Contract No. SS D505

Environmental Permit No. EP-454/2013

**Reprovisioning of FEHD Sai Yee Street Environmental Hygiene Offices-cum-Vehicle Depot
at Yen Ming Road, West Kowloon Reclamation Area**

Landscape and Visual Mitigation Plan (Rev. B) – Clean Version

drawing title	TREE PLANTING PLAN AT GROUND FLOOR	
drawing no.	AB/7919/EW401	scale 1:200

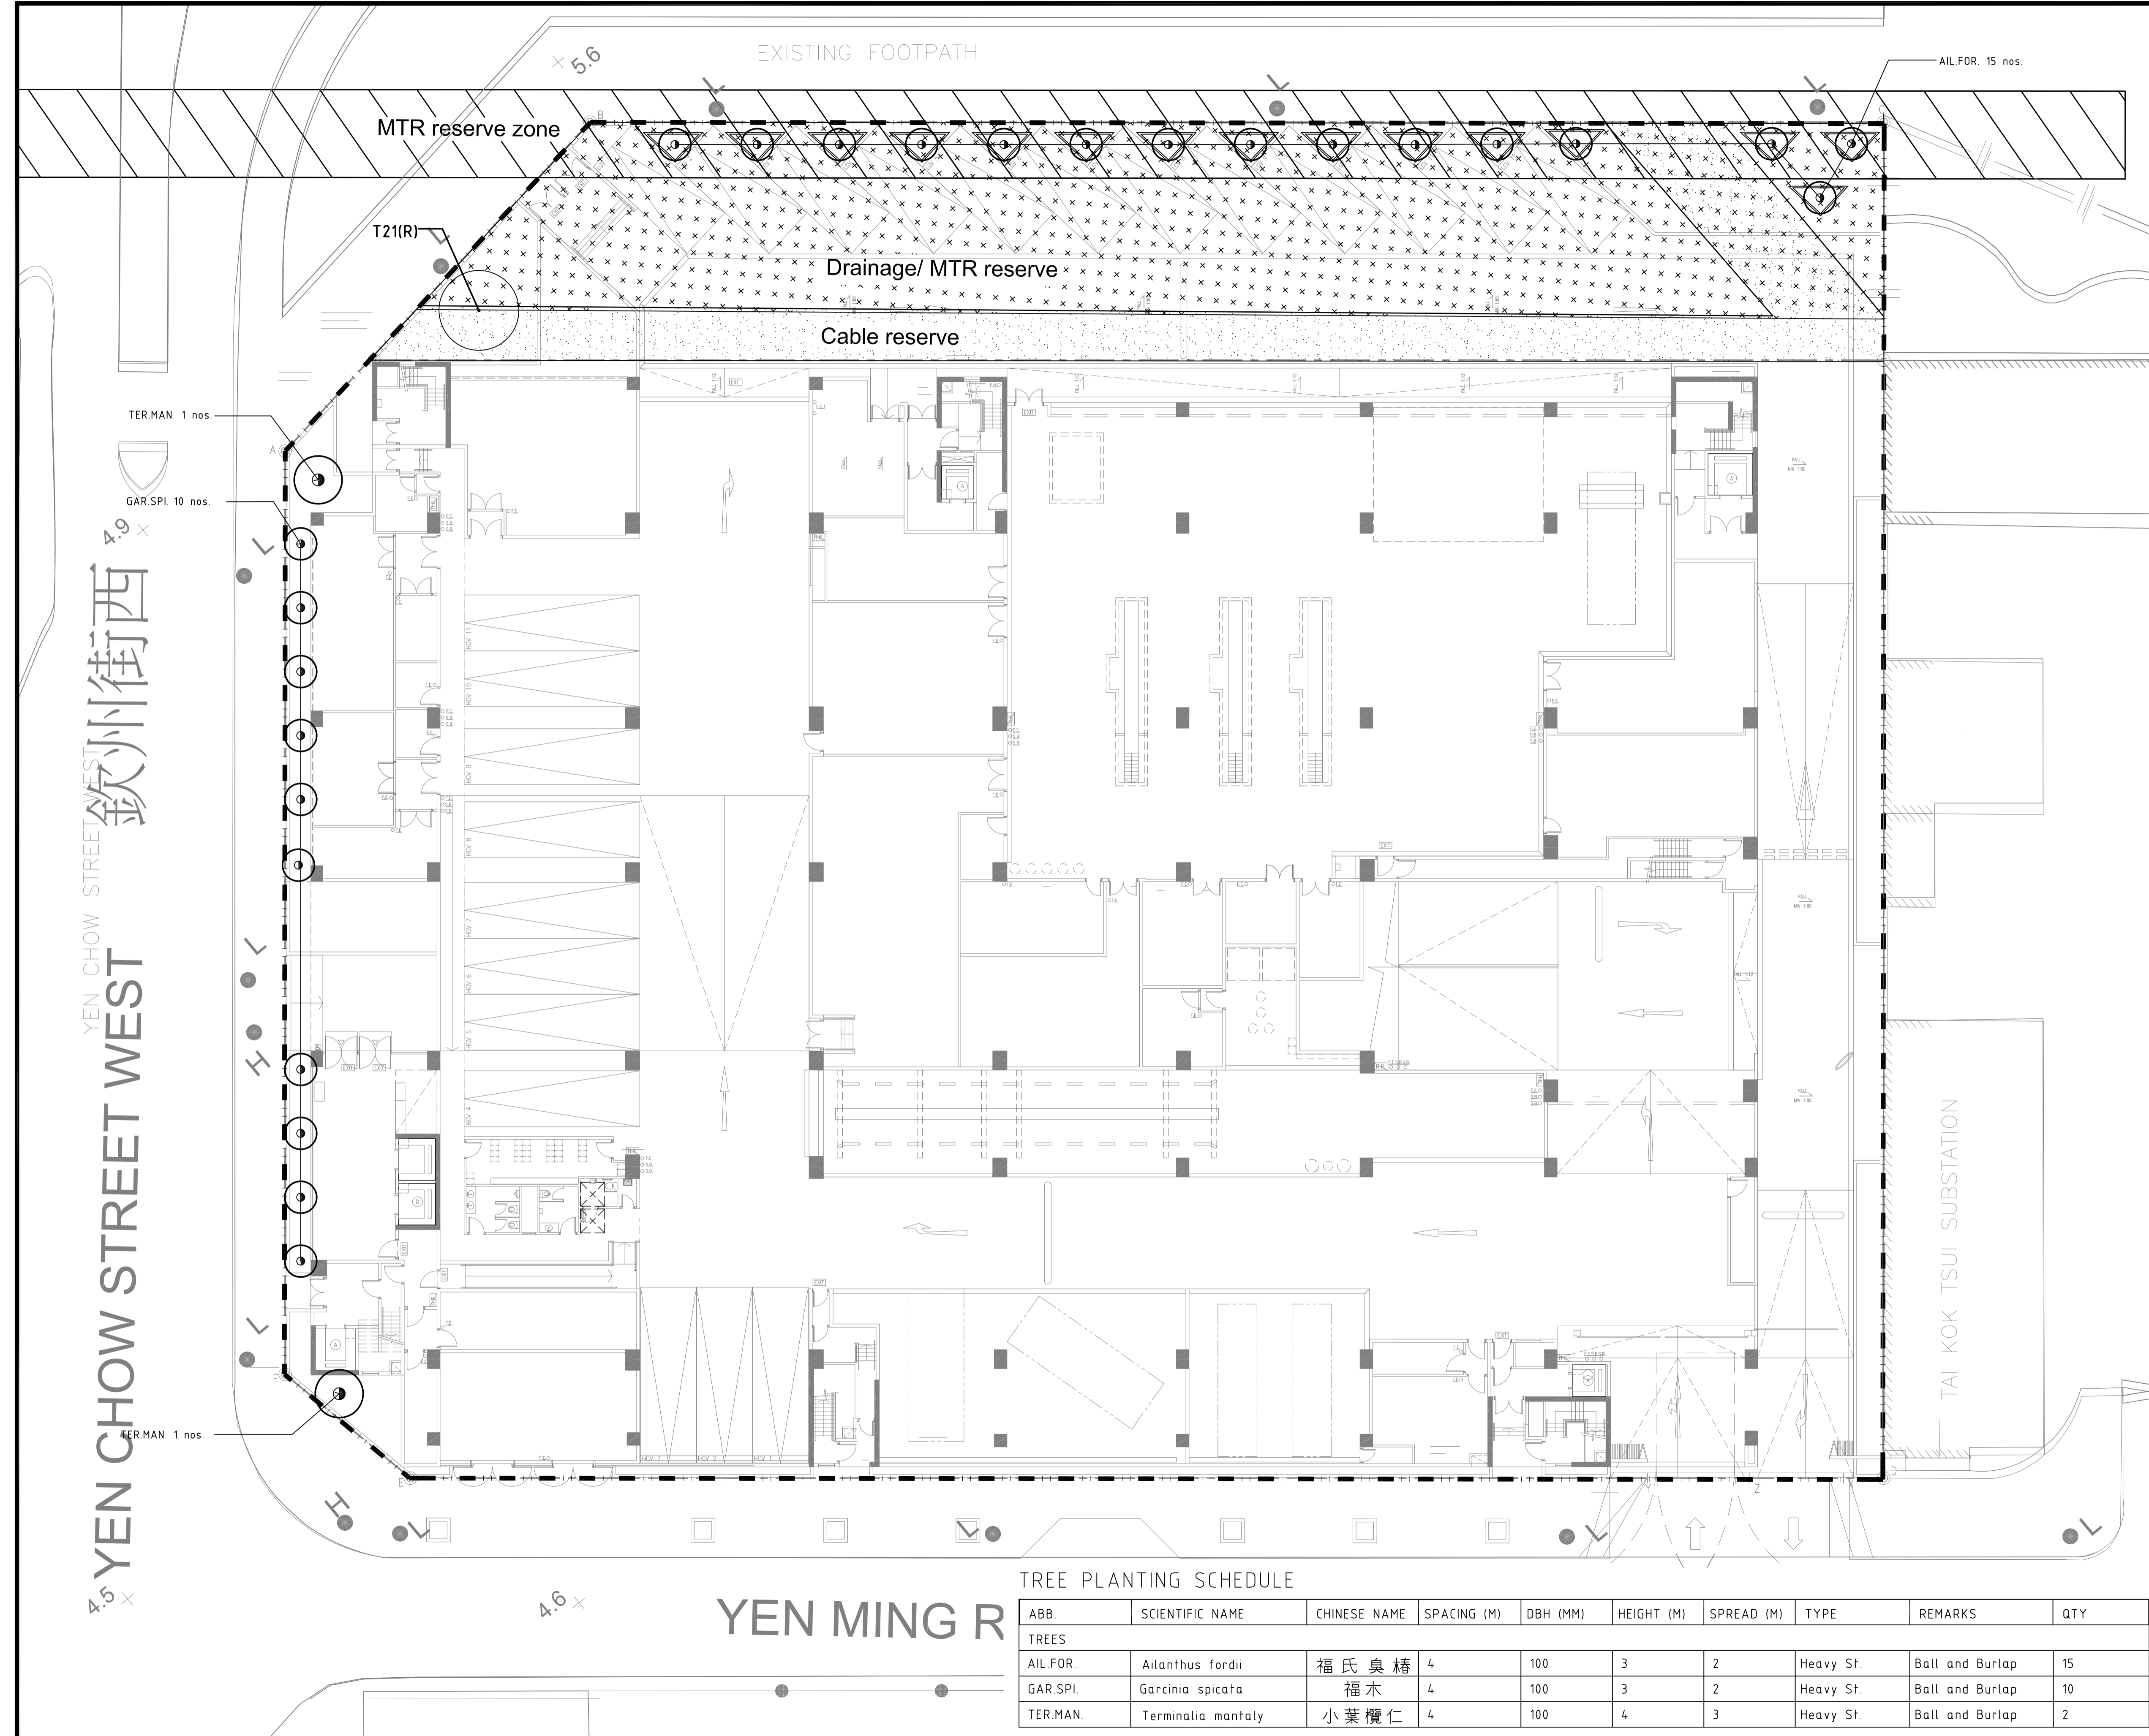
- (i) Since 15 new trees of AIL. FOR. are proposed to be planted on raised planter boxes situated on top of the drainage / MTR reserve, the project proponent is required to seek the comment and agreement from concerned authority.
- (ii) It appears that the width of planting area facing Yen Chow Street West for the LAG.SPE. on the ground floor is approx 1.5m which is quite narrow and may not be sufficient enough for the future growth and development of the trees and the tree crowns. The project proponent is advised to review the planting proposal by observing the TMO's relevant guidelines on selection of species and proper planting practice and to provide adequate growing space for the future growth of canopy of trees as well as

provide sufficient growing space between trees and adjacent building / structures.

- 3.2. **Appendix 2** shows the locations, size, number and species of trees to be planted, including the compensation of 27 trees of heavy standard size (100mm DBH) on drawing no. AB/7919/EW401.

drawing no. AB/7919/EW402	scale 1:200
------------------------------	----------------

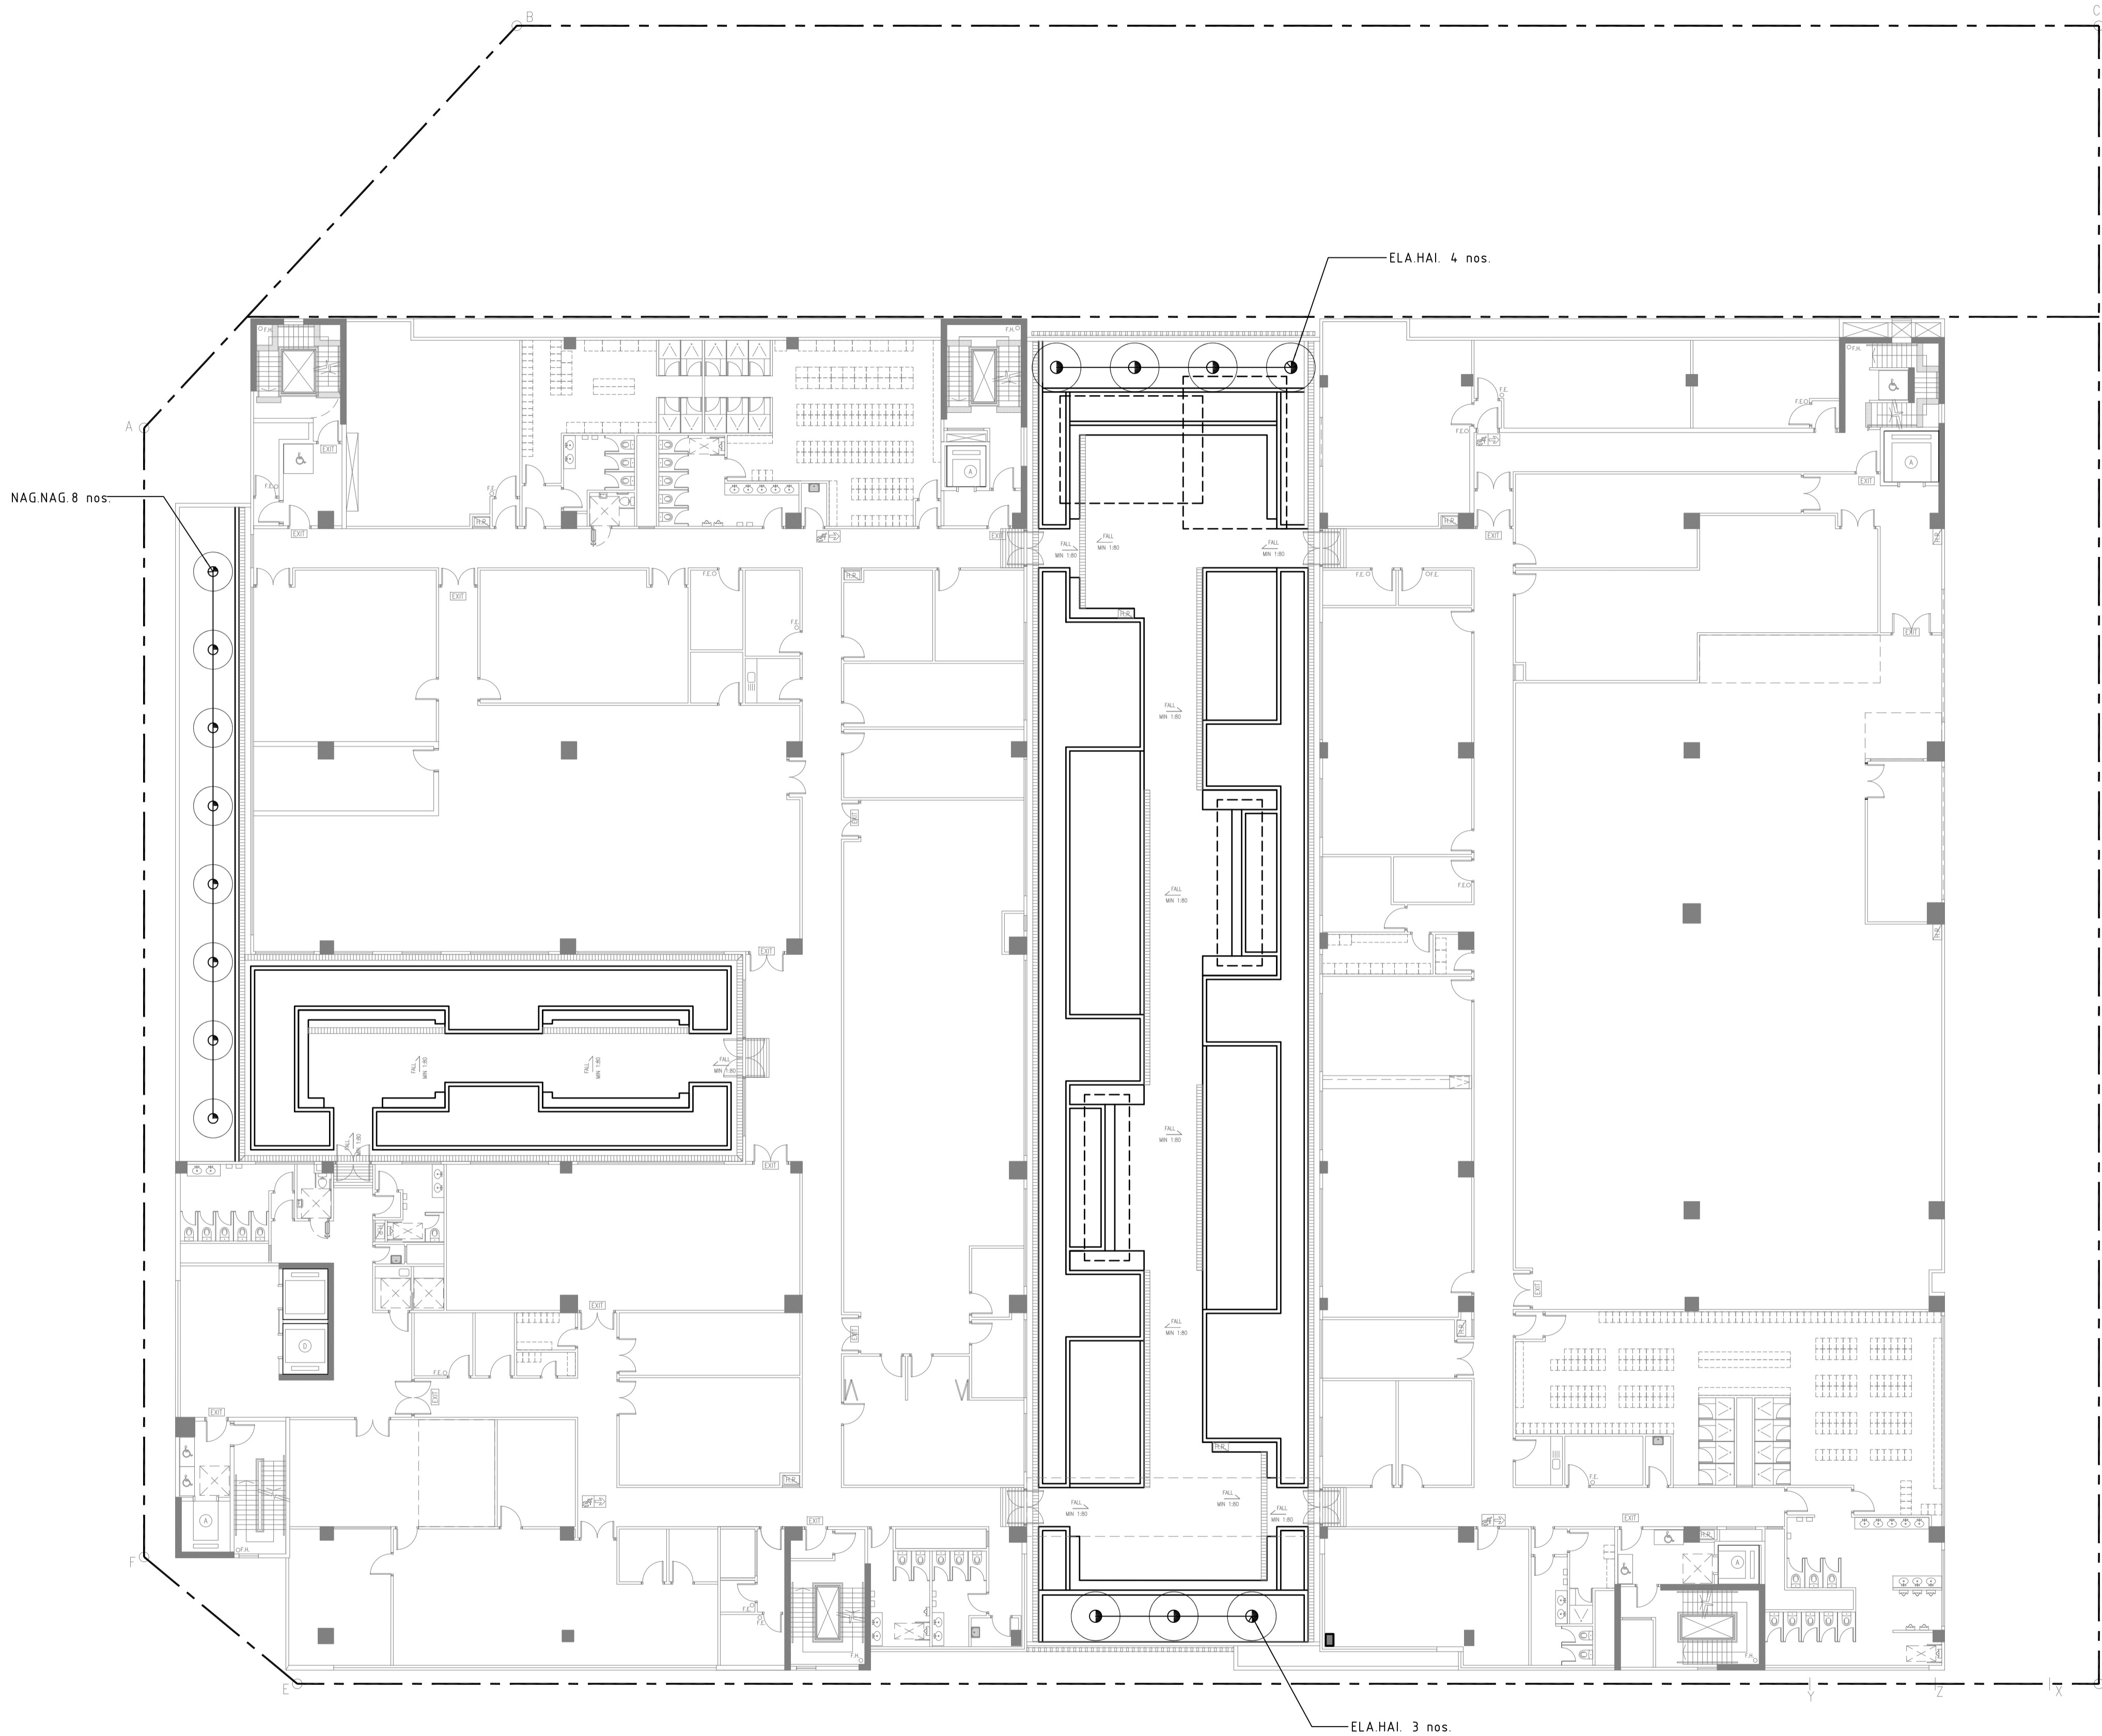
No.	Comment	Response
	<p>contained in the EIA Report (Register No.: AE1AR-177/2013).</p> <p>3. Having reviewed the submission, please find below the comments from the landscape and visual perspectives. Please revise the LVMP and submit four hardcopies and one electronic copy of the LVMP for our approval within one month of the receipt of our comments as required under Condition 1.8 of the E1.</p> <p>(i) Referring to Drawing No. AB/7919/EW403 (Shrub and Groundcover Planting Plan at Ground Floor), please elaborate on the proposed landscape treatment in relation to the retained tree. Relevant information such as the existing and proposed levels of the retained tree and planters, and whether there is any footing/underground works within the tree protection zone should be provided.</p> <p>(ii) According to the description of operational phase mitigation measure OMM2.3 (Roof Garden) in the approved EIA report (Register No. AEIAR-177/2013), there will be tree planting which will be planted either in planters or in ornamental pots at the Roof Garden. According to Drawing No. AB/7919/EW402 (Tree Planting at Third Floor), <i>Gordonia axillaris</i> (大頭茶) with a diameter at breast height of 30mm is proposed at the Roof Garden. The proposed size cannot be considered as a tree. Please provide tree planting with heavy standard size under the recommended tree species on Roof Garden as stated in the EP.</p>	<p>A 500mm radius around the trunk of the retained tree shall remain clear of shrubs or ground covers in accordance with Guidelines promulgated by the Development Bureau, and a 50mm layer of mulch shall be applied. The existing ground level at the trunk base of the retained tree is +5.49mPD, which is the same as the proposed top of soil level of the planter at +5.49mPD. Also, there is no footing / underground works proposed within the tree protection zone.</p> <p>The diameter at breast height of <i>Gordonia axillaris</i> (大頭茶) is proposed to be 30mm due to market availability and to allow further growth and better establishment of the trees. To provide tree planting with heavy standard size, we propose to replace <i>Gordonia axillaris</i> (大頭茶) with <i>Elaeocarpus hainanensis</i> (水石榕) with a diameter at breast height of 75mm. Please refer to Drawing No. AB/7919/EW402 (Tree Planting at Third Floor) (Rev. B) in Appendix 2.</p>
